KUDZ ZE KAYAH PROJECT

RESPONSE #3 TO YESAB EXECUTIVE COMMITTEE INFORMATION REQUEST KZK

June 2018

**FIGURE 7-2
WATERFOWL HABITAT SUITABILITY
WITHIN LOCAL STUDY AREA**

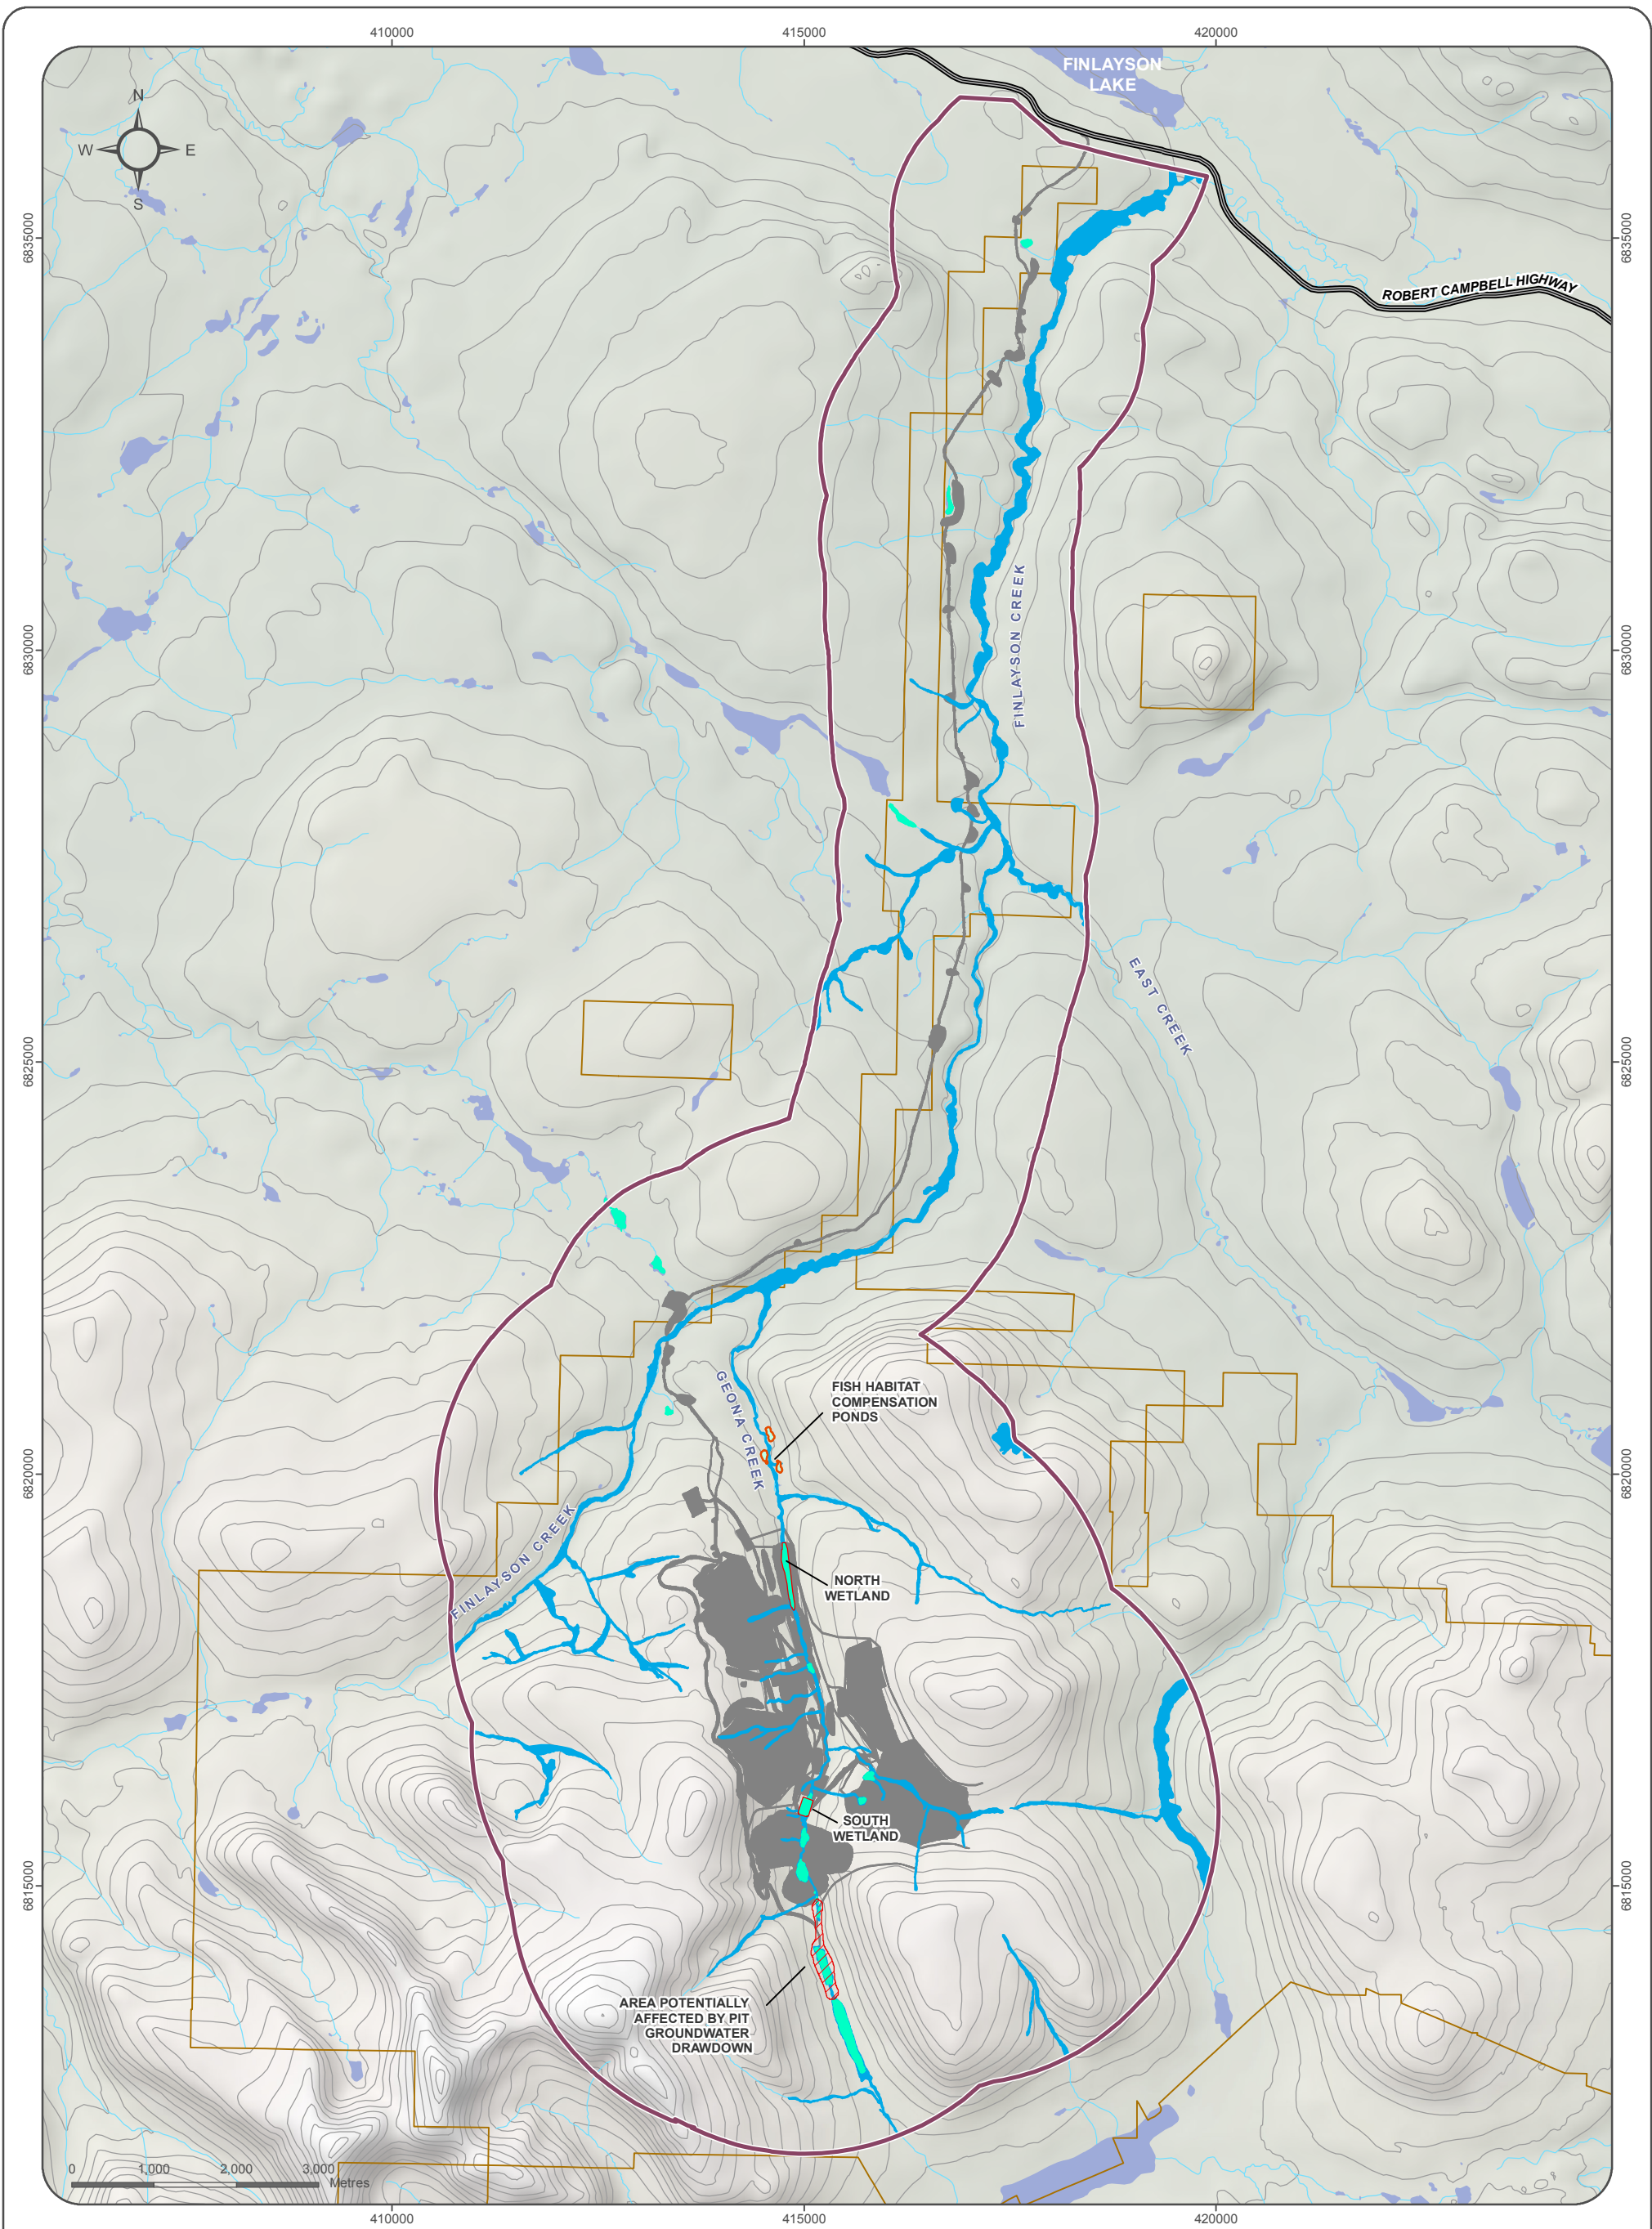
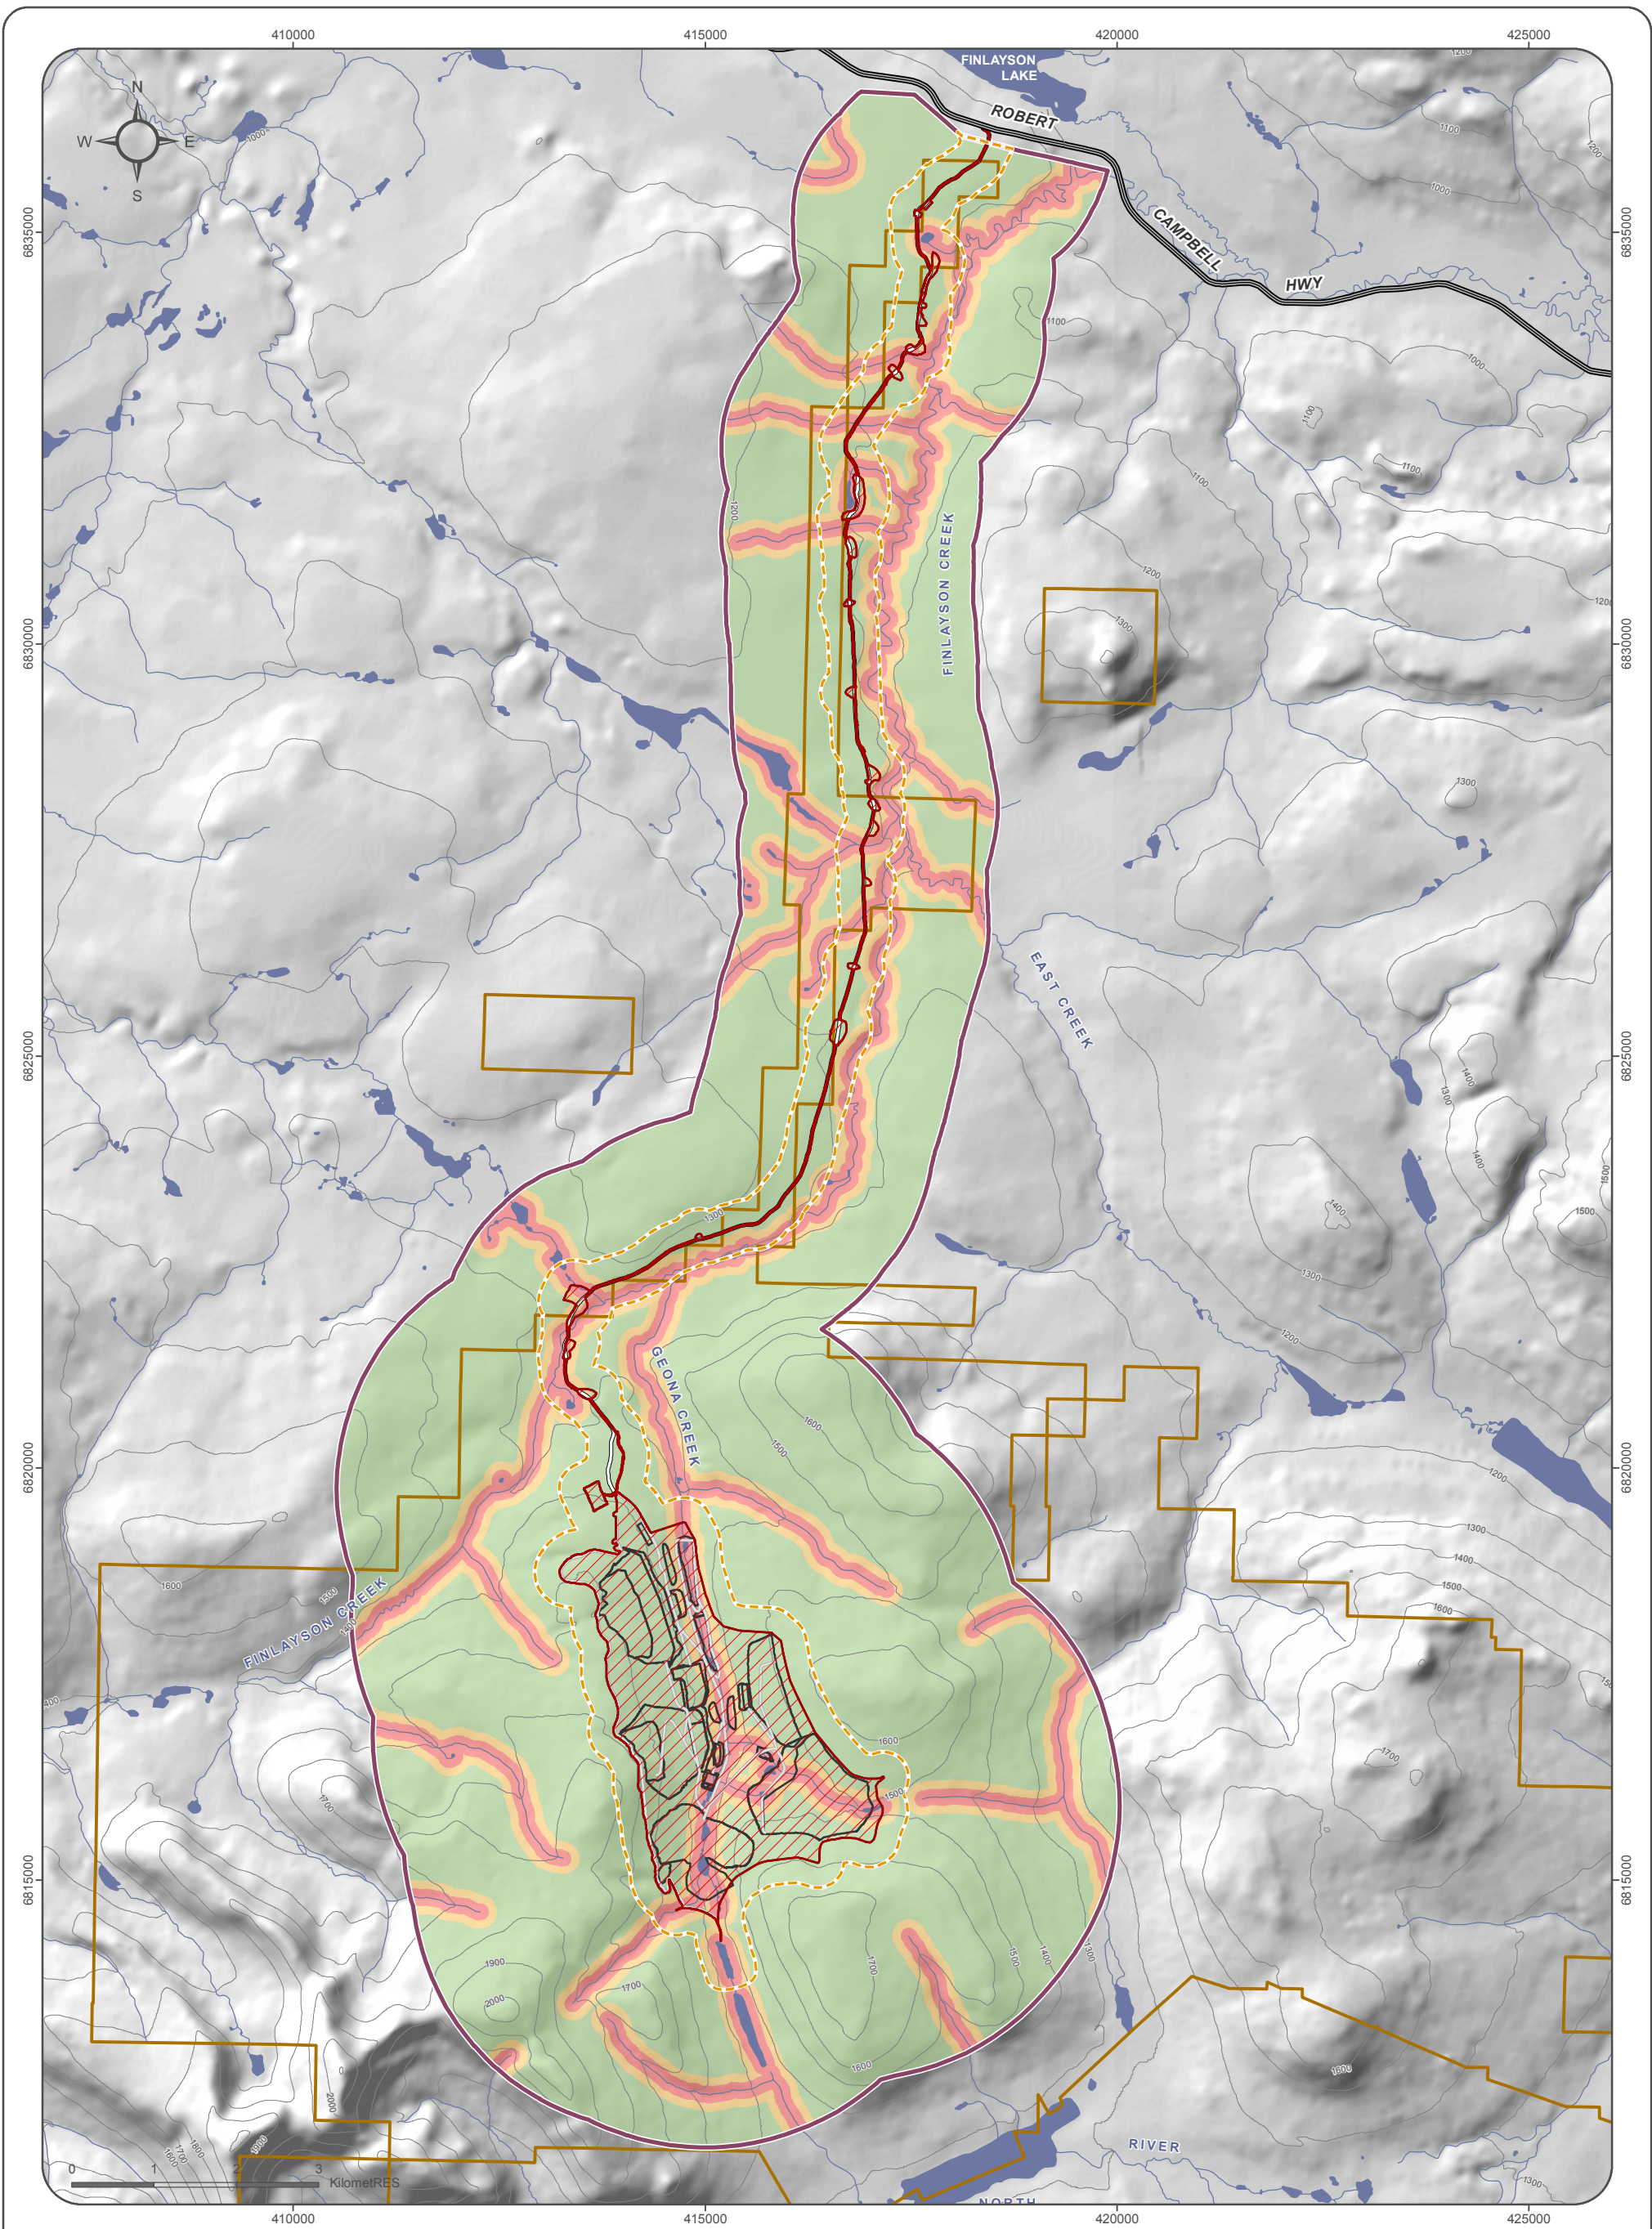
R3-14 is the same question asked of BMC during the Adequacy stage of the assessment process:

Waterfowl and shorebird habitat is directly related to effects on wetlands and riparian areas. The effect on wetland and riparian areas was assessed in Section 12.4.1.2 of the Project Proposal, which showed the pond area that would be affected by the open pit drawdown and the diversion of Fault Creek. Figure 12-5 from the Project Proposal is included below as Figure 7-1 for reference. As discussed in the wetland effects assessment, groundwater, surficial materials, and bedrock conditions were assessed for this area and it was calculated that the open pit and diversion would result in an overburden aquifer drop of approximately one metre in the area of the uppermost pond and wetland. Following closure, Fault Creek will be rerouted into the Geona Creek valley to fill the open pit and then flow to Geona Creek after the pit is filled. As a result, flows in the South Creek drainage will drop to approximately 89% of their baseline flows and rebound to approximately 90% of their baseline flows once the pit is filled. The resulting effects on the wetlands and riparian areas of the South Creek are difficult to predict. For the purposes of this assessment, it is estimated that the flow changes and reductions will result in a loss of 10% of wetland and riparian vegetation in this area.

This expected loss of wetland and riparian habitat in this area was captured in the calculation of indirect loss of waterfowl habitat presented in Table 13-18 and Figure 13-19 of the Project Proposal and repeated below as Table 7-1 and Figure 7-2 for clarity.

**FIGURE 8-1
EXTENT OF DUST DEPOSITION
DURING OPERATIONS (WORST CASE)**

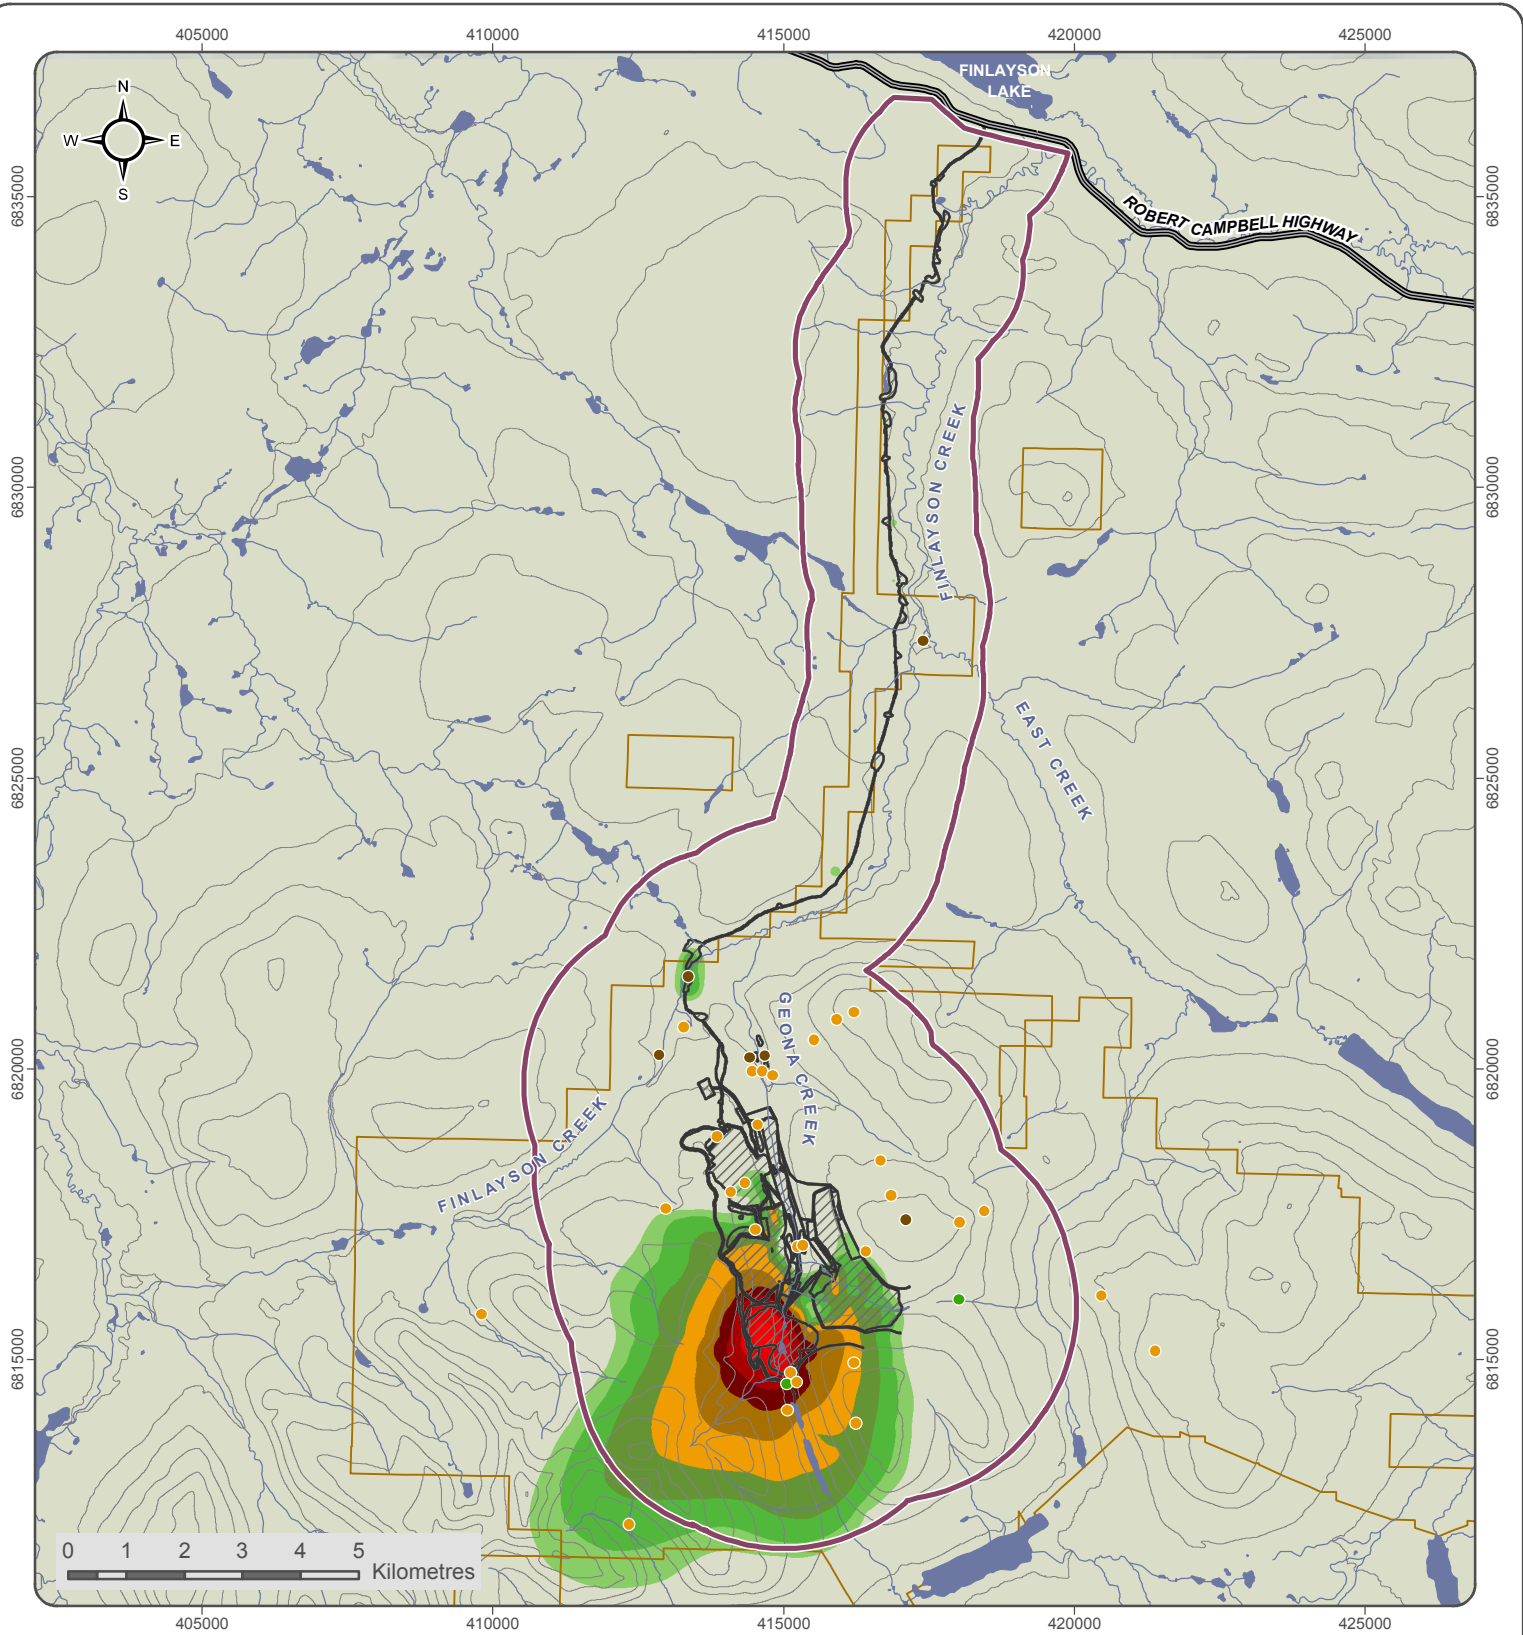
In addition to ambient air concentration modelling presented in Chapter 6 of the Project Proposal, TSP deposition rates were modeled. The results of this modelling for the operation phase (worst case) were presented and discussed Chapter 12 (Vegetation) of the Project Proposal and are reproduced below for easier reference.

Project related activities occurring in the construction and operation phases may cause a potential short-term impact on metal concentrations in plants used for traditional purposes and wildlife browse. More specifically, the construction activity of pit development and operation activities of open pit operations, ore processing, and storage facilities operations can generate dust that disperses in the prevailing wind currents and settles on soil and vegetation and thereby can be absorbed or transported into the plant. Figure 12-7 of Chapter 12 of the Project Proposal shows the results of the dust dispersion model (for the operations phase when there is maximum dust generation) and is included here as Figure 8-1 for clarity. The model input parameters and results are outlined in Appendix E-1 of the Project Proposal. Based on the modelling, open pit blasting is the primary source of dust and dust dispersion patterns spread some to the east, but mostly to the southwest due to the prevailing northeast winds. It should be noted that the pit is expected to contain reasonable quantities of water and that pure 'dry' blasting is not expected. This model therefore predicts a worst-case scenario that includes the conservative assumption that all equipment will be operating at once (which will not occur during the life of the Project) and that blasts are at the surface for the life of the Project (which will only occur during a portion of the construction period). Atmospheric transport of dust is also expected from the Class A and Class B Storage Facilities, the ROM Pad, and Low Grade Ore Pad and unpaved roads, these sources were included in the model.
